# SERVICE BULLETIN #127

04/25/14

## 9560 Spoke Wheel

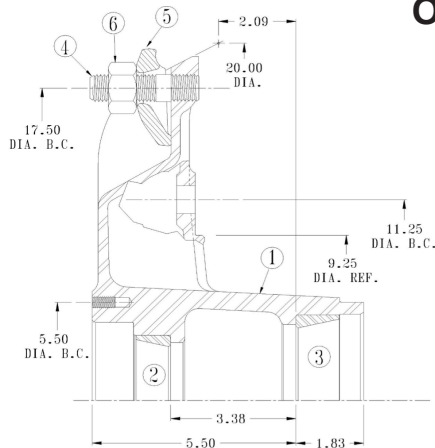
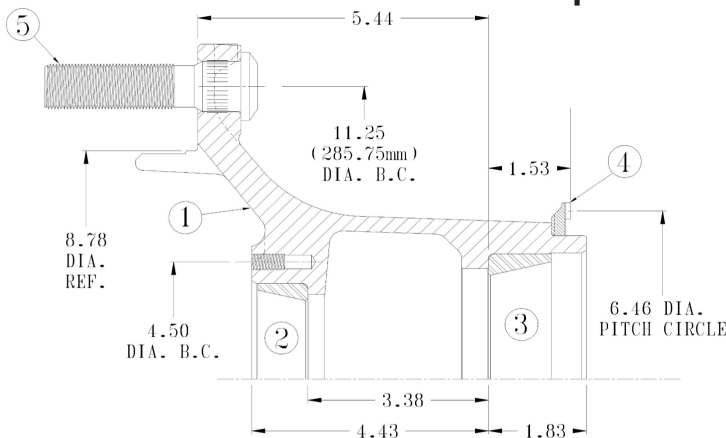
Upon depletion of inventory, the 9560 spoke will become obsolete with no direct replacement. We do however recommend a replacement: the 10-stud 2520 hub. This requires changing brake drums, changing to a disc hub, and changing to disc wheels instead of demountable rims. If you have any questions, please contact the Webb Engineering department via email to [engineering@webbwheel.com](mailto:engineering@webbwheel.com) or call 256-736-6356.

### Replacement Option
